**DEPARTMENT OF TRANSPORTATION****National Highway Traffic Safety Administration****49 CFR Parts 571 and 585**

**Federal Motor Vehicle Safety Standards; Child Restraint Systems, Child Restraint Anchorage Systems, Incorporation by Reference****AGENCY:** National Highway Traffic Safety Administration (NHTSA), Department of Transportation (DOT).**ACTION:** Final rule.

**Figure 1. Proposed Clearance Angle Tool (CAT)**

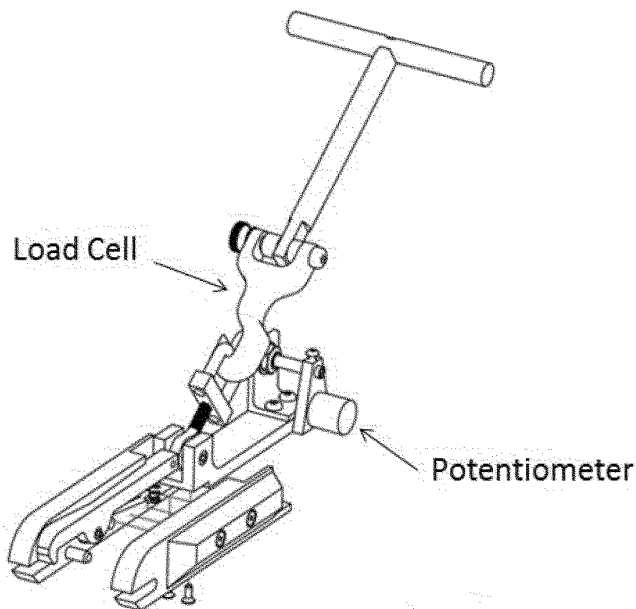
Some of the Alliance members commented on their experience with the SAE Prototype and UMTRI clearance angle test devices. The members stated they found those devices difficult to use and not sufficiently repeatable. GM and FCA commented that oscillations caused by the free-hanging weight attached to the rotary potentiometer resulted in non-repeatable measurements. GM recommended replacing the rotary potentiometers on the CAT with a digital inclinometer connected to a data acquisition system.

2. This final rule modifies the hand-held tools used to measure clearance angle and anchorage depth proposed in the NPRM. Comments received stated that the proposed tools yielded inconsistent results and were hard to use. In response, NHTSA undertook several studies, discussed below in this preamble, to refine the proposed tools and validate their improved repeatability and reproducibility in measurements. This final rule adopts these improved test tools.

**Figure 2. Proposed Attachment Force Tool (AFT)**

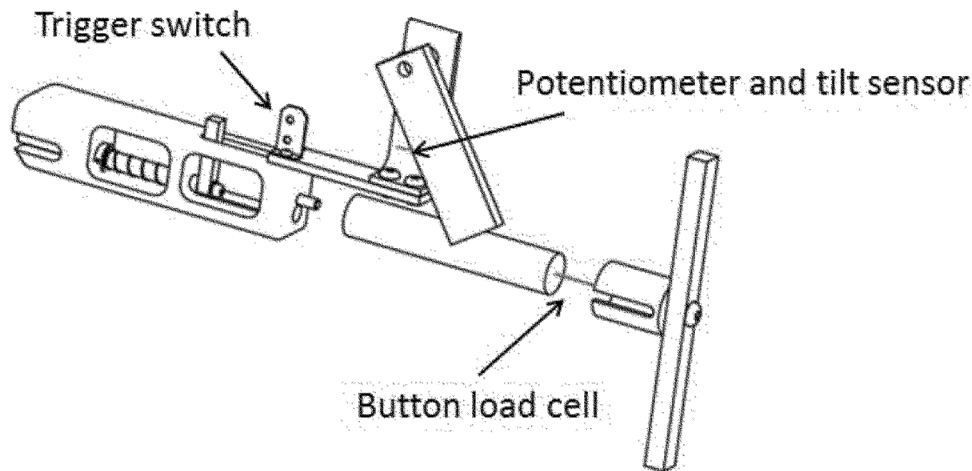
GM commented that the AFT does not provide real-time feedback, making it difficult to ensure the operator performs the insertion force measurement at a consistent angle with the 0–45-degree range specified. GM noted that this would be particularly important if the

trim interferes with insertion of the tool. GM added that the operators found the AFT angle difficult to control with the short T-handle (*see* figure 2) while trying not to touch the tool beyond the load cell. GM found that a digital inclinometer was helpful in observing the angle and improved its confidence in the force data being collected. GM recommended that the rotary potentiometer be replaced with a digital inclinometer including a real-time readout for the operator and a signal output for data acquisition. GM also suggested that the T-handle be replaced with a longer axial handle to improve control of the insertion angle and to avoid touching the tool along the load path.

GM commented that the AFT does not indicate to the operator that the switch used to detect full engagement of the tool on the anchorage bar has been activated. GM explained that this lack of an indication could result in a “no switch closure” event, and that the peak attachment force prior to bottoming out cannot be determined if this happened. GM added that if the AFT was not sufficiently perpendicular to the anchorage bar, it would be possible to mechanically bottom out the tool without closing the switch and that the perpendicular requirement is dependent on the distance the slide pin must travel before activating the switch. Additionally, GM stated that, depending on the lower anchorage style in the vehicle, particularly for non-visible anchorage bars, it can be difficult to determine perpendicularity.

GM requested that the current tool be revised to allow a larger tolerance to the range of perpendicularity, as a child restraint anchorage connector may be attached at a larger range of angles than the current tool design. GM suggested that this goal may be accomplished by lengthening the slide pin or increasing the thickness of the slide tab and that either solution will allow the slide tab to close the switch earlier during anchorage bar engagement and increase the perpendicularity tolerance. GM also recommended that an LED be included on the tool to indicate to the operator when the switch is closed.

**Figure 3. Proposed Anchorage Depth Tool (ADT) (left) and Top View (right)**

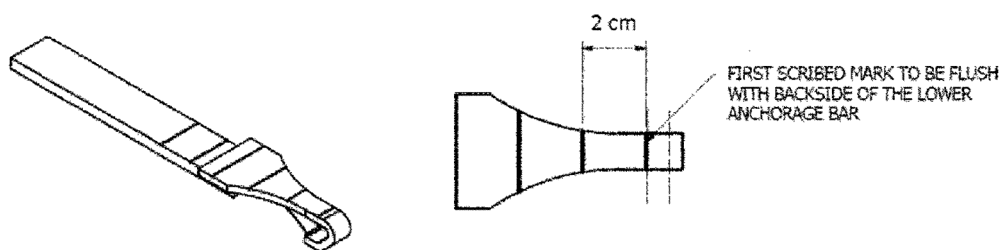
The Alliance explained that the current requirements for FMVSS No. 225 are based on the visibility of the lower anchorages around the soft trim and that the current FMVSS No. 225

present.<sup>43</sup> GM requested clarification of the procedure regarding trim covering or surrounding trim being displaced by the tool and the angle of the tool during determination of the depth measurement. The Alliance stated there were differences between the UMTRI LATCH Usability study and the NPRM ADT measurements. The Alliance noted that the UMTRI Study specified no tension on the hook, which implies that the ADT will lie on the seat cushion, while the Vehicle Research and Test Center (VRTC) study was kept approximately parallel with the seat cushion. The Alliance added that S9.2.2(a) did not specify any tension to be maintained in the ADT, so it is implied that the tool would lie on the seat cushion when making the measurement. GM recommended that the test procedure require that the tool be kept parallel to seat cushion when reading the depth measurement.

For the depth measurement<sup>49</sup> NHTSA modified the ADT through the addition

Figure 4. Three-Dimensional 325 mm Zone.

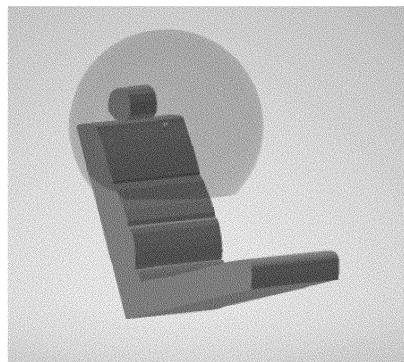
points into a 2D circle diagram. Due to the offset, measurements for that tether anchorage do not correctly capture the depth distance. Therefore, VRTC used a

325 mm sphere (truncated at the bottom) instead of a two-dimensional circle to define the 325 mm zone (see figure 4).

**Figure 5. Chevrolet Express Tether Anchorage**

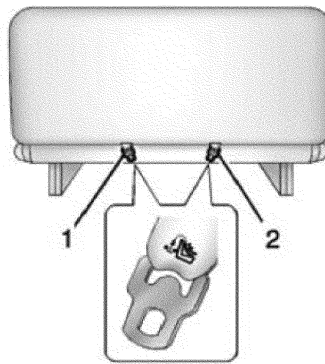
GM requested that buses under 10,000 pounds gross vehicle weight (*i.e.*, 12 and 15 passenger vans) be exempt from the requirement that the tether anchorages be a rigid bar. GM pointed out that school buses are already exempt altogether from requirements to provide any tether anchorages. GM explained that the 12–15 passenger van segment is a very small (much less than 1 percent of total market sales) specialized segment of vehicles which are typically driven by employees or individuals affiliated with a business or organization. GM provided figure 5 below showing the metal anchorage in these vehicles is attached to a flexible strap which is bolted to the lower seat structure. GM also noted that the seats in these vehicles have a single seatback shared by 3 or 4 seating positions and that these seats are already quite heavy and would become even heavier if additional structures were added to it to handle CRS tether loading. GM explained that today, as marked, these anchorages are readily recognizable and easy to use. GM recommended allowing flexible strap tether anchorages for bus applications.

**Figure 7. FMVSS No. 225 Figure 22 (left) and Updated FMVSS No. 225 Figure 22 (right)**

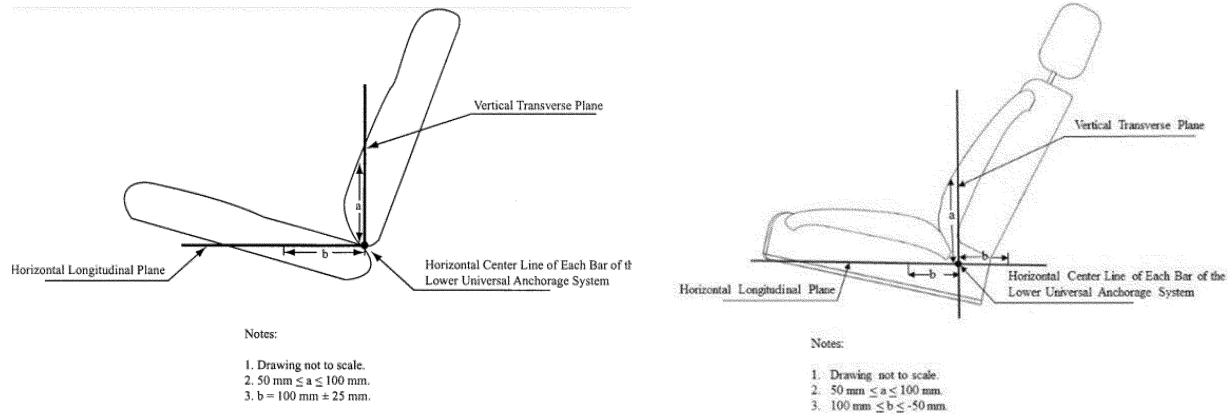
mm (forward) to  $\pm 50$  mm. Specifically, a 25 mm (vertical) distance above the lower anchorages may be too small, as the contour of the seat may position the marking downwards, making it difficult for a customer to see. Additionally, a 125 mm distance may be too far away from the lower anchorage to be able to identify the correct equipment.

However, NHTSA does agree that the horizontal zone should be expanded to accommodate seat contours where the marking would be positioned behind the anchorage when a visible anchorage is more forward. Therefore, NHTSA is expanding the allowable horizontal zone for marking from +100 to  $-50$  mm (see figure 7) for this final rule.

**Figure 8. NPRM Regulatory Text Figures 25 (left) and 16 (right): ISO Tether Symbols**

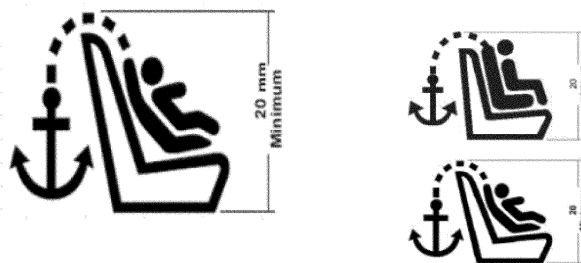
MEMA commented that the reference to the figure 25 pictogram in the NPRM indicated that the tether anchorage cannot be less than 20 mm in diameter, but pointed out that the figure itself actually shows a height of 20 mm, rather than a diameter. MEMA expressed concern that the 20 mm diameter on the tether anchorage may not include the entire pictogram for some applications (depending on the function/design of the tether anchorage component); therefore, MEMA urged NHTSA to revise the regulatory text to refer to a height, rather than a diameter.

Similarly, Global, GM, and the Alliance stated that given the manner in which the pictogram measurement is shown in figure 25 of the proposed

regulatory text, along with the irregular shape of the pictogram, the 20 mm criterion can more appropriately be described as “height,” rather than “diameter.” Finally, the Alliance stated that the “circle” referred to in the last line of 9.5.2(b) means a “symbol” in figure 25, and should be referenced as such in the regulatory text.

NHTSA agrees with the aforementioned comments expressing concerns over the reference to the diameter, rather than the height, in relation to figure 25 of the NPRM, and is correcting the proposed regulatory text in response to these comments. As such, this final rule will state that the tether anchorage marking cannot be less than 20 mm in height. NHTSA also agrees with the Alliance’s statement that the “circle” referred to in the last line of 9.5.2(b) means a “symbol” in figure 25 of the NPRM, and this final rule will reference the marking as a symbol

Figure 11. Tether Anchorage Symbol Centered to Tether Anchorage (horizontally)

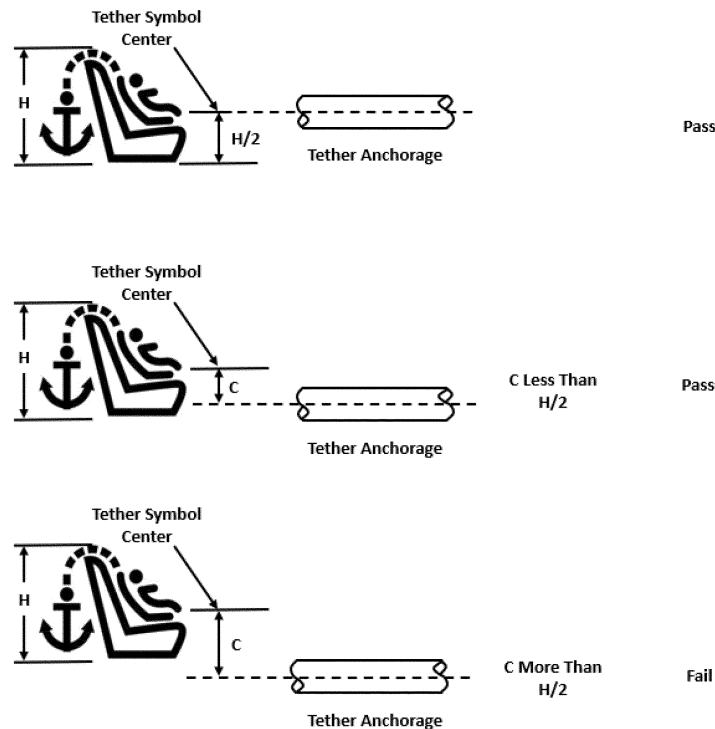
The agency also agrees with the Alliance that in some cases it would be difficult to align the tether anchorage marking to the width of the tether anchorage. However, NHTSA would like to keep some consistency on the

location of the markings to easily guide the consumer to the tether anchorage. Therefore, NHTSA will also allow locating the tether anchorage marking to the sides of the anchorage. Per this final rule's requirements, half of the height of

the marking must overlap/intersect the tether anchorage, as shown below in figure 11. Manufacturers may choose a larger symbol size (with a minimum height of 20 mm) that gives them the flexibility to meet this requirement.

**Figure 12. NPRM Figures 26 (left and center) and 27 (right): Tether Anchorage Marking Locations with No Cover and Cover Respectively.**

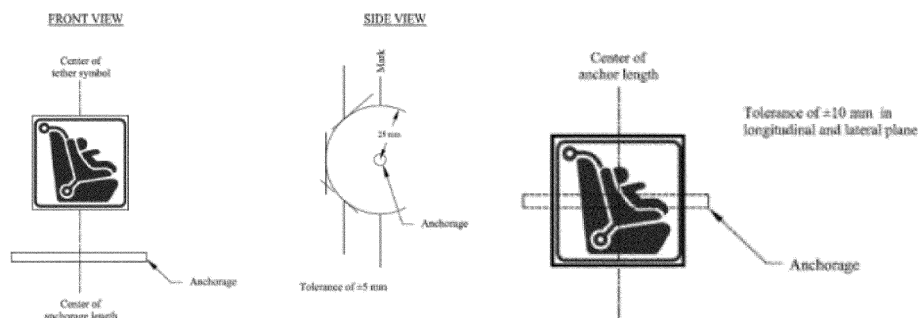
MEMA and the Alliance stated that figures 26 and 27 referenced in the proposed regulatory text (figure 12) depict a different pictogram than the proposed ISO Tether Symbol inside a label and that the pictogram is not referenced elsewhere. MEMA requested clarification on this issue and asked that NHTSA use consistent pictograms in all of its figures in the regulation.
